ABILENE SQUARE

Amended Site Plan and Use Approval Sheet 1 of 3

PROJECT: NIXON POWER HOME DEPOT - AURORA

ES-01

2 DELTA 23 SITE PLAN

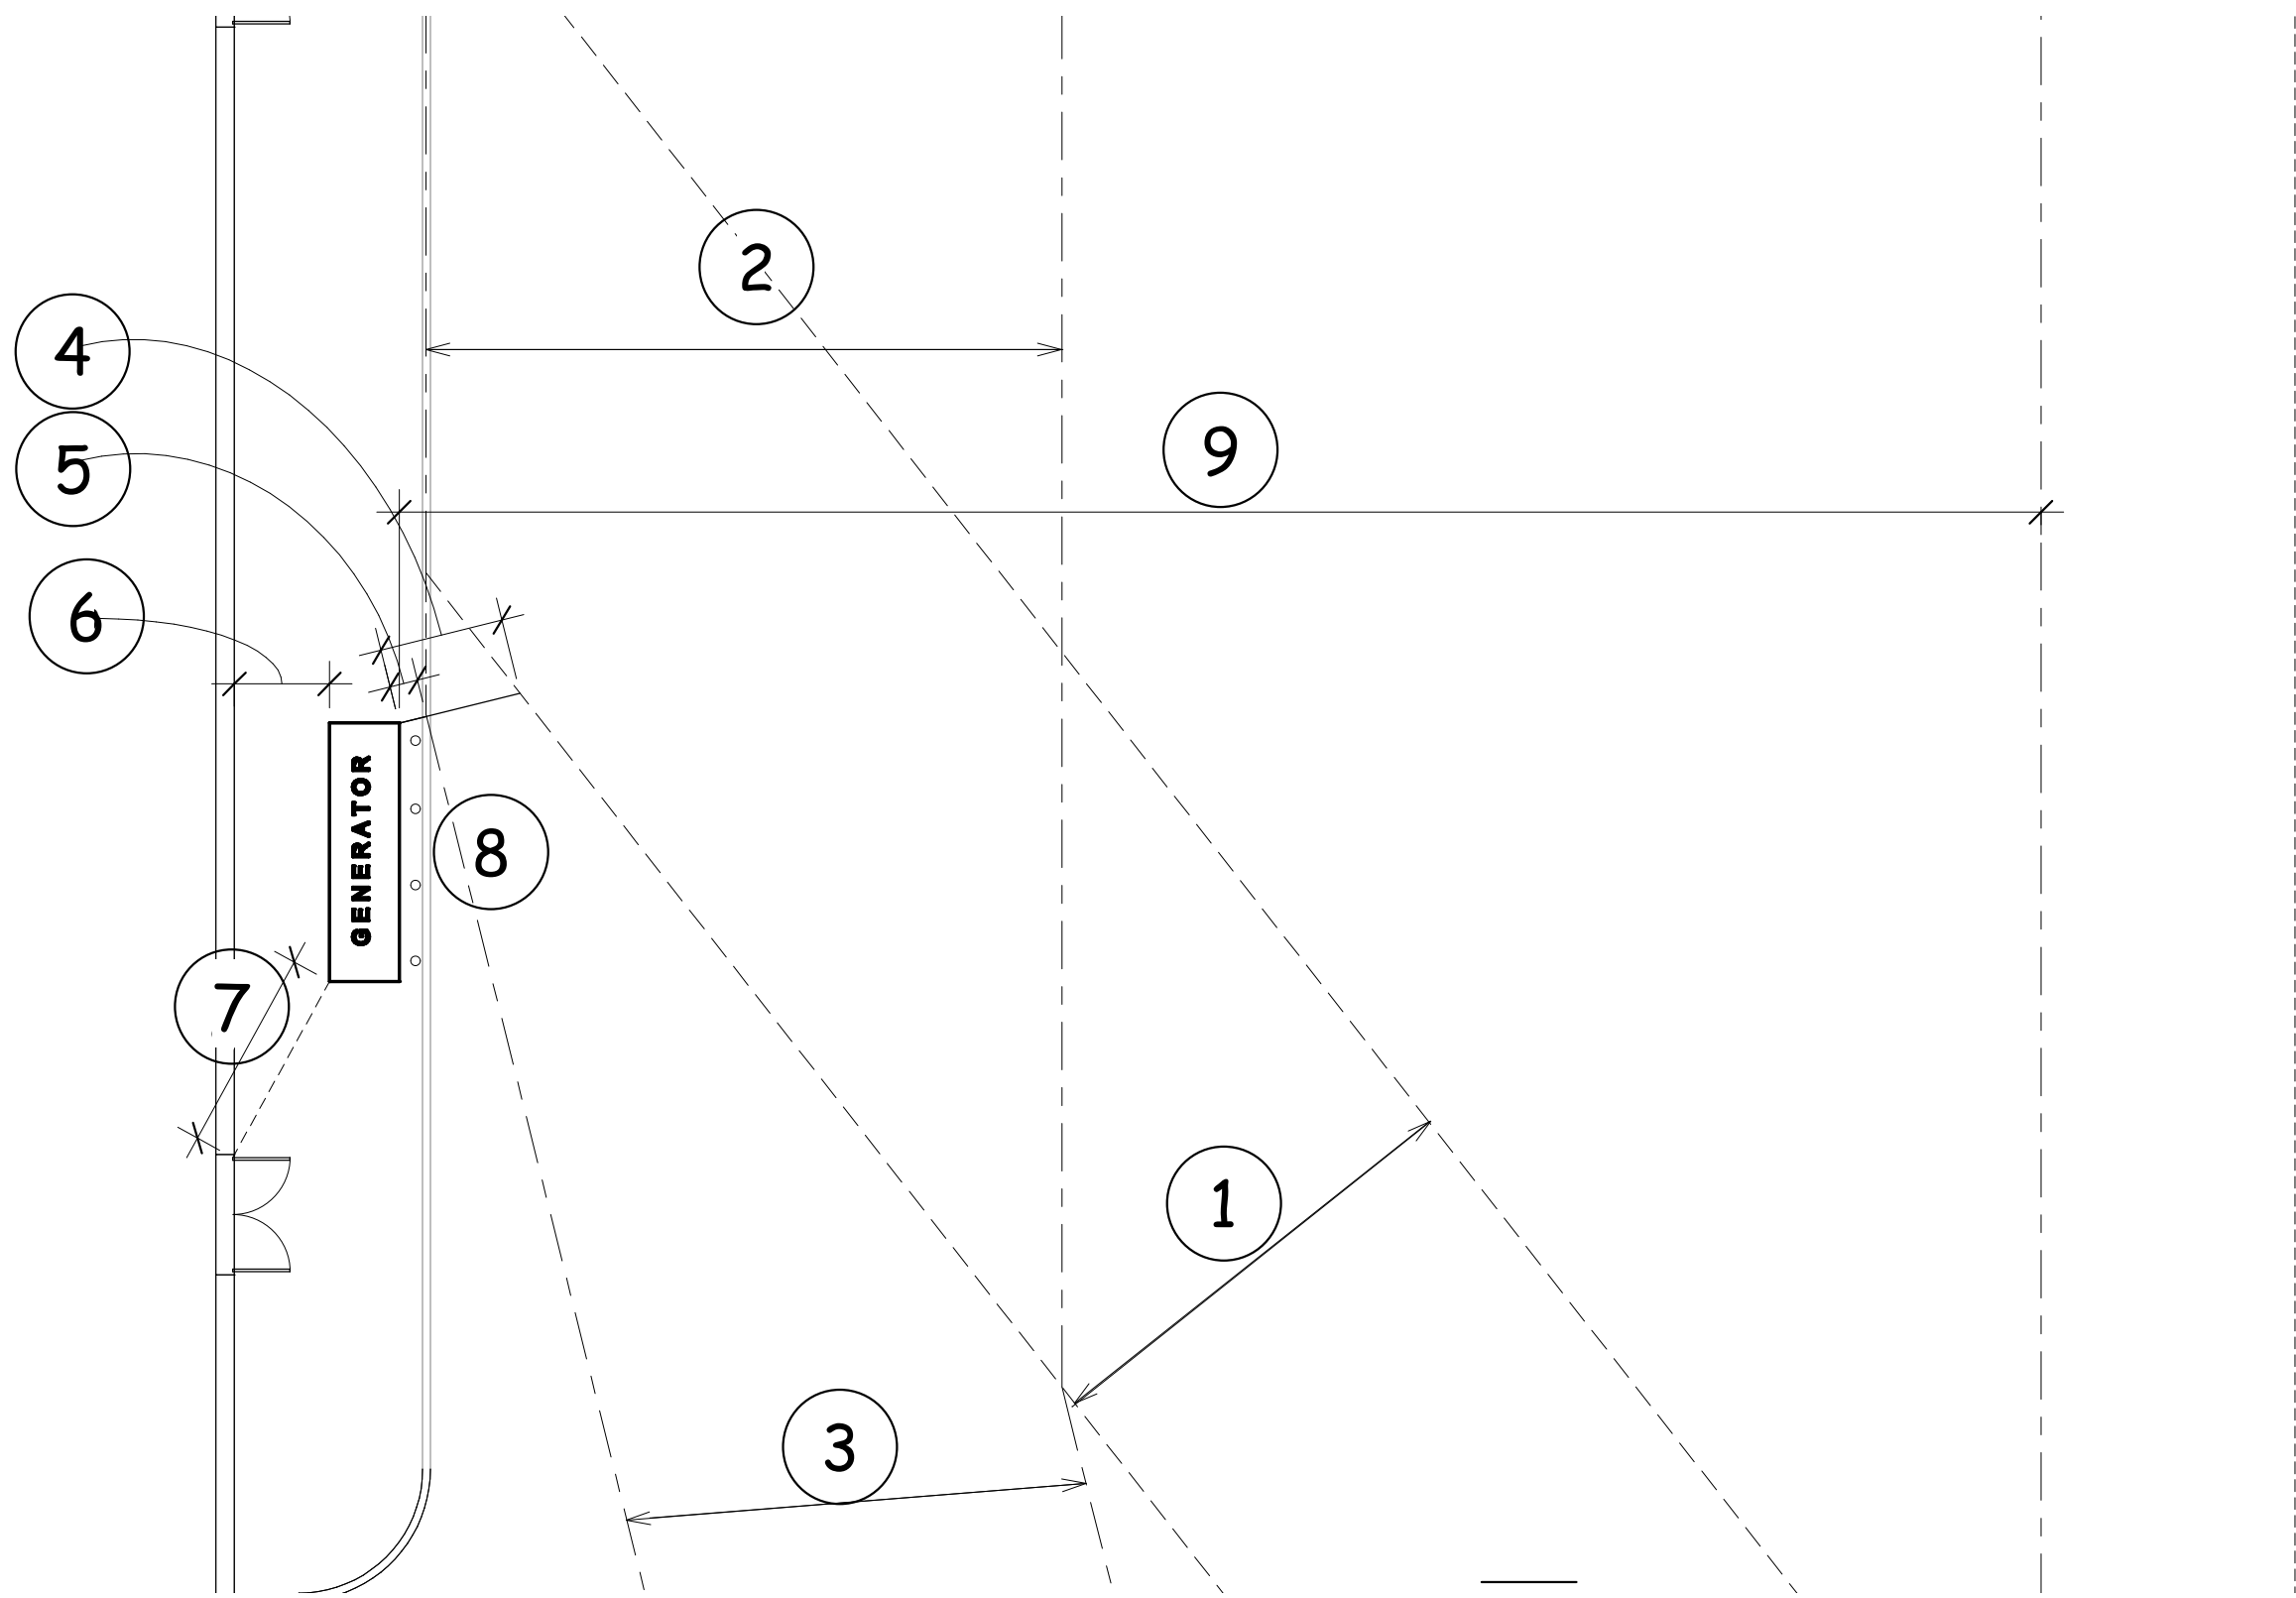
- ADMIN. AMDT. 9/15/94
CHANGE LAND USE DATA INFO TO REFLECT EXISTING CONDITIONS.
- 21 AMENDMENT #21: 12/31/01 ~~ADD PROPOSED SIGNAGE~~
b) Cart storage at entry ways, c) Add outdoor merchandize area, d) Expansion of the Garden Center, west, e.)
Add signage, barricade & tree west of bldg.
- 22 Amendment #22
44' W x 28' D x 6' H Add 3 propane Exchange Cages
- 23 RELOCATE GENERATOR TO CURRENT LOCATION.

- 1 26'-0" DRAINAGE AND UTILITY EASEMENT
- 2 26'-0" FIRE LANE DRAINAGE AND UTILITY EASEMENT
- 3 26'-0" FIRE LANE AND UTILITY EASEMENT
- 4 6'-6" FROM GENERATOR TO EDGE OF 1 DRAINAGE AND UTILITY EASEMENT
- 5 1'-6" FROM GENERATOR TO EDGE OF 3 FIRE LANE AND UTILITY EASEMENT
- 6 5'-0" FROM GENERATOR TO BUILDING
- 7 10'-7" FROM GENERATOR TO DOOR OPENING
- 8 BOLLARDS BETWEEN GENERATOR AND CURBLINE. POSITION AND QUANTITY TBD
- 9 GENERATOR TO PROPERTY LINE 86'-0"
